Re: Des Moines Independent Community School District
Central Campus HVAC Upgrades
1800 Grand Avenue
Des Moines, Iowa 50309

ADDENDUM #1

February 5th, 2021

ASD 01

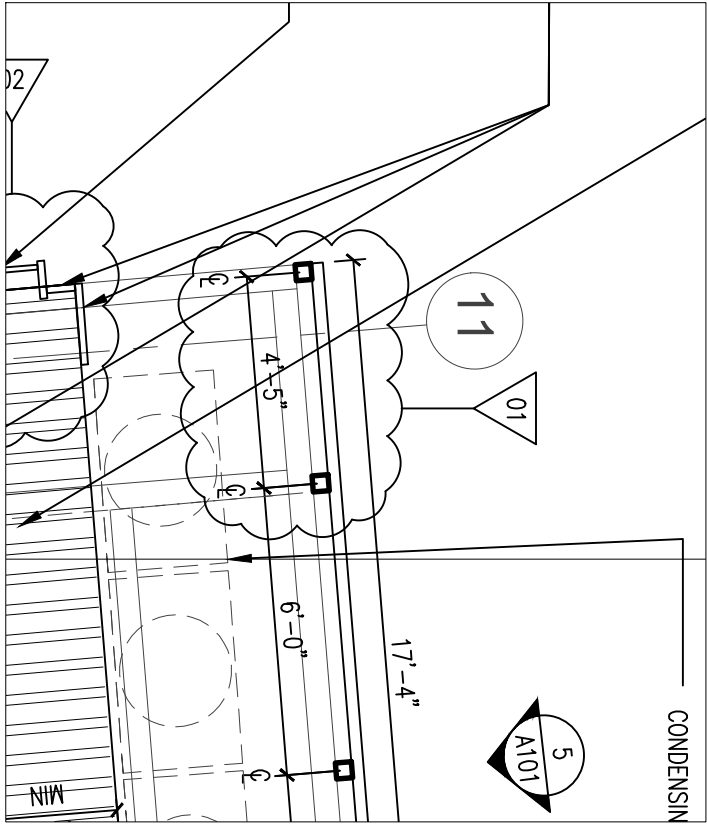
Item #A1: **REVISION – MECHANICAL SCREENING LENGTH**
On Sheet A100 an additional section of louvered mechanical screening is added to cover the mechanical equipment.

Supplemental Drawing ASD01 is included at the end of this addendum and is intended to replace the area shown on sheet A100.

ASD 02

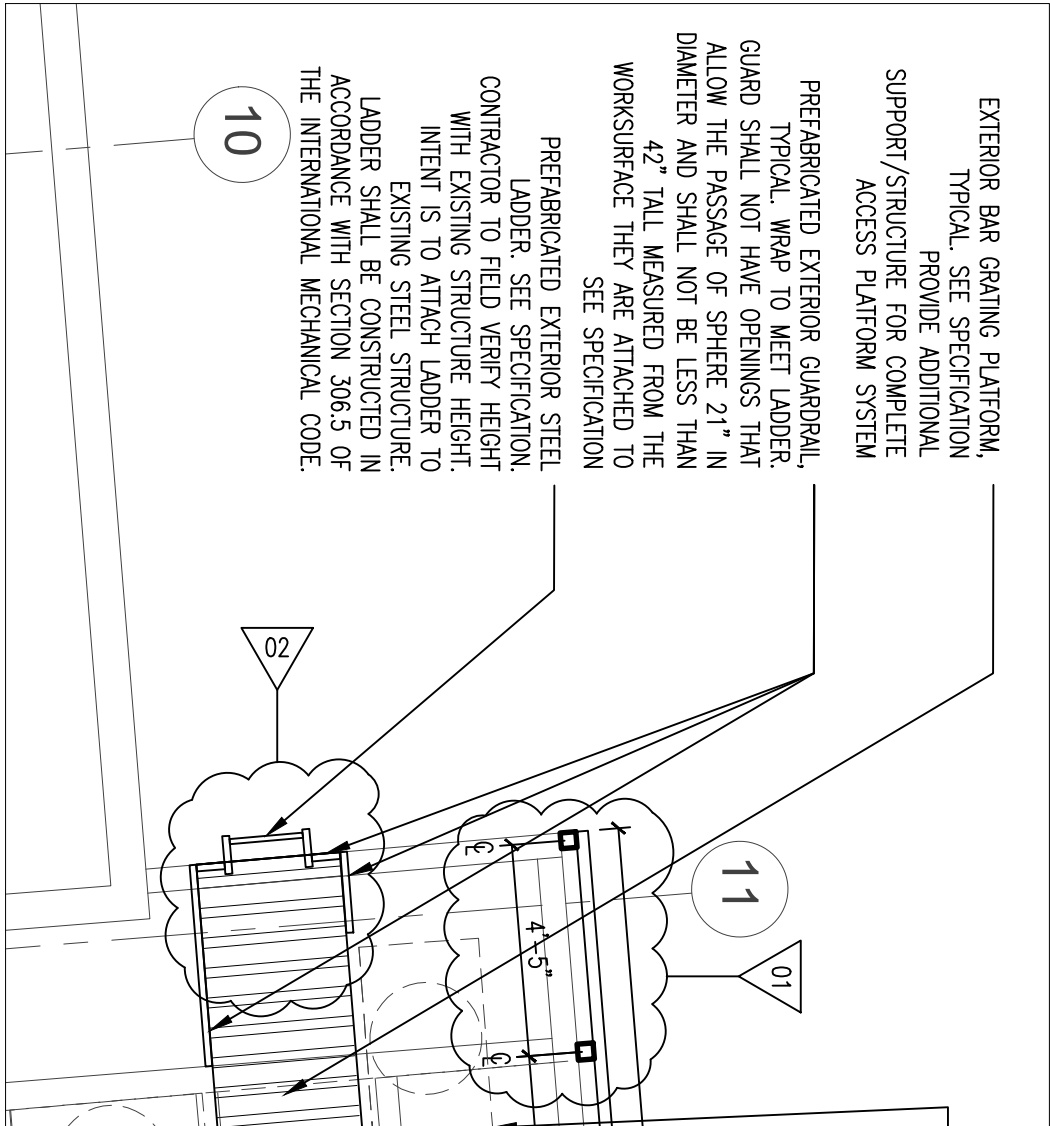
Item #A2: REVISION – PRE-FABRICATED STEEL ROOF STAIR

On Sheet A100 the pre-fabricated steel stair is replaced with a pre-fabricated steel ladder.

Supplemental Drawing ASD02 is included at the end of this addendum and is intended to replace the area shown on sheet A100.
